Rezoning Transportation Analysis

Petition Number: 2018-118

Revision Log:	Date	Description
	10-12-18	First Review
	11-19-18	Second Review

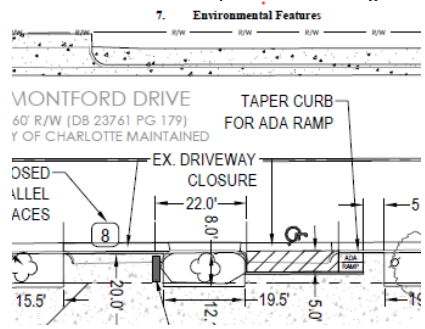
2. **Traffic Study** A Traffic Impact Study/Transportation Technical Memorandum is not necessary for the complete review of this petition.
3. The petitioner should revise the site plan and conditional note(s) to show amenity zone as approved in previous 2017-116 rezoning. **MUDD zoning requires 6' sidewalk separated by planting strip.**

Commented [W11]: Section 9.8506 (2)(d) "If no street scape plan exists, a six-foot sidewalk is required along all streets separated by a planting strip in accordance with the Charlotte Tree Ordinance [Chapter 21 of the City Code]. The Park Woodlawn plan on specifies for Montford but not the "unnamed street"

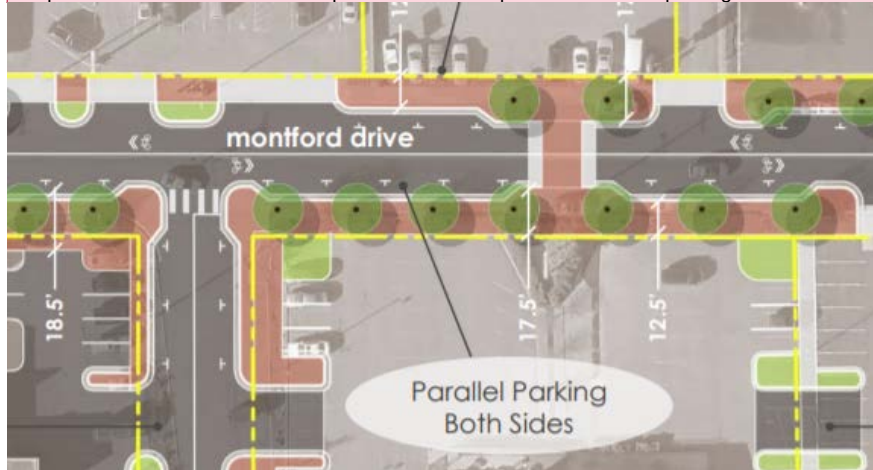
- The petitioner should revise the site plan to create bump out for on-street parking of Montford Drive.

Commented [W12]: According to Tom S, curb is not moving but will have extensions, Pic also from Tom Sorrentino, currently project is not funded
